Item 9. Groundwater Quality Data

Figure 9.1 Example Terminal Electron Acceptor (TEA) Map – Dissolved Oxygen

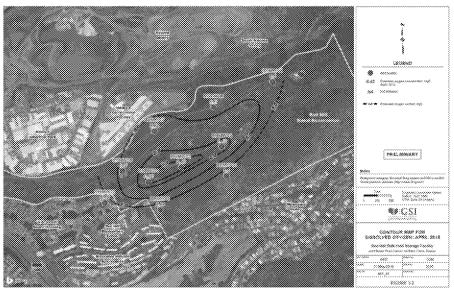
Problem encountered: The interpretation of groundwater quality data presented in interim TUA documents is in places non-conservative, and conflicts with other lines of evidence and with conclusions reached by regulator SMEs. Example 1: the Navy consultants dismiss some detected results out of concerns for data quality. Even if justified, this does not address all detected results, and from the regulator perspective, if any of the reported detects are real this is

evidence impacts occurred. Example 2: TEA data (Inset Figure 9.1) as indications of natural attenuation, dissolved phase contaminant detection frequency and distribution (inset Figure 9.2), and hydraulic gradients, all suggest transport occurred not just to the southwest but also to the northeast of the facility. Example 3: the distribution and concentrations of general chemistry data (i.e. major ions, specific conductivity, and pH) show a poorly-mixed system inconsistent with the Navy CSM of robust flow from upslope recharge areas to Red Hill Shaft. The chemistry is highly variable with chloride concentrations spanning over an order of magnitude and is more suggestive of sluggish down-slope flow and compartmentalization (inset Figures 9.3 and 9.4).

The relative absence of high-concentration detections within the small, widely-spaced, monitoring network around Red Hill is not proof of absence of impacts, but appears to be interpreted as such by the Navy consultants. Other data, including TEAs, TPH and individual fuel constituents suggest a broad area of groundwater impacts that extends in various directions, a complex groundwater flow system that is not uniformly Mauka-to-Makai, and the possibility of LNAPL impacts at the water table as the cause.

The final CSM should at this stage allow for "alternative hypotheses" of at least equivalent likelihood of LNAPL impact to groundwater versus the current hypothesis of there having been no impact. The final groundwater flow model, when it reasonably represents hydraulic gradient directions and magnitudes in the vicinity of Red Hill ridge, would be anticipated to underpin a contaminant transport model that demonstrates a reasonable match historical sample results (contaminants and TEAs, etc.), thereby demonstrating that the model is useful for near-field transport to understand the available groundwater data, and for developing predictions of contaminant transport and fate to help evaluate risk and mitigating responses or strategies.
